MFN 06-239

Subject: **Additional Information to Support Draft RAI 21.6-53**

**Material Properties for the Sodium Pentaborate  
Standby Liquid Control System Injection Liquid**

RAI 21.6-53 A (Draft)

Figure 21.6-53-1 Density Curve of Sodium Pentaborate Solution

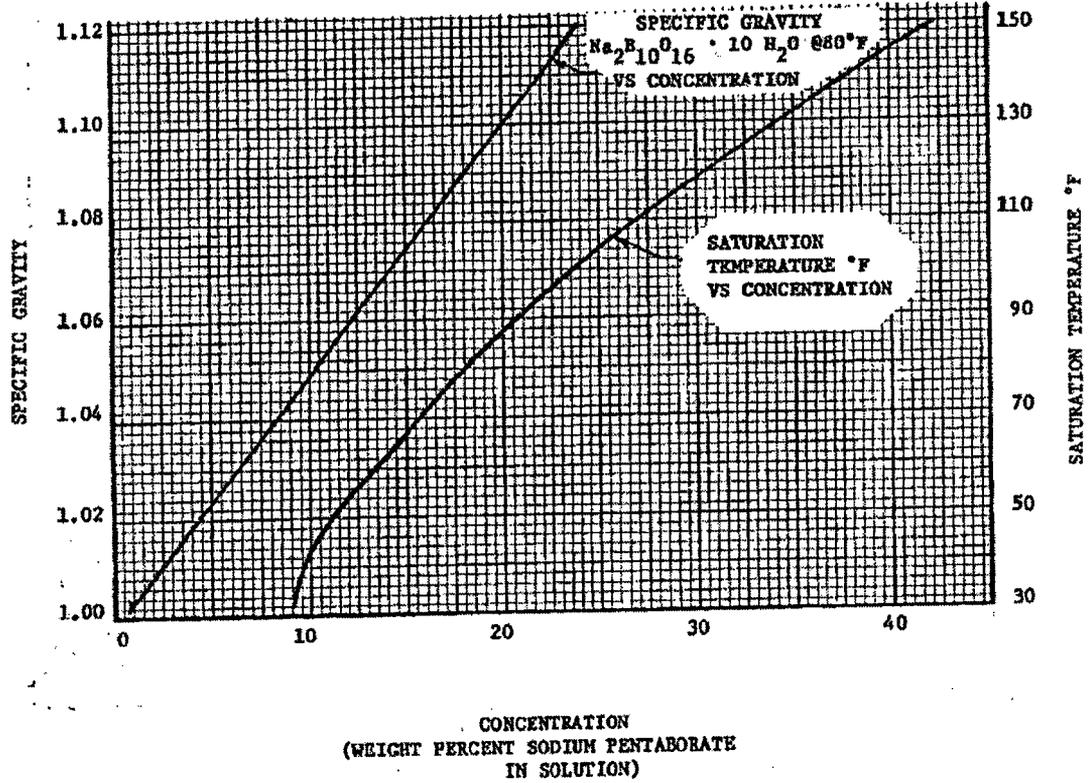
*Material properties for the sodium pentaborate standby liquid control system (SLCS) injection liquid: ( $T$ ) (density as a function of temperature),  $C_p$  (specific heat capacity),  $k$  (thermal conductivity), ( $\mu$ ) (viscosity), and mass diffusivity. The staff needs the density as a function of temperature. If available, the staff would also prefer the other properties as a function of temperature.*

The relative density (specific gravity) as a function of concentration at 80°F is provided in Figure 21.6-53-1. A good approximation of the specific gravity at other temperatures can be found by assuming that the change in the specific gravity of the solution with temperature is proportional to that of water. Though figure 21.6-53-1 is for sodium pentaborate with natural boron, the change in the density curve for ESBWR enriched boron is insignificant.

The specific heat capacity, thermal conductivity, viscosity and mass diffusivity of the sodium pentaborate should be approximated with the same properties of water or sodium pentaborate solution with natural boron. The SLCS injection solution is only 12.5 weight % of  $\text{Na}_2\text{B}_{10}\text{O}_{16} \times 10\text{H}_2\text{O}$ , which is only a small fraction sodium pentaborate. Using the requested properties of water will have a negligible difference in the calculation. GE will be modeling the injected solution as water in the ATWS CFD model.
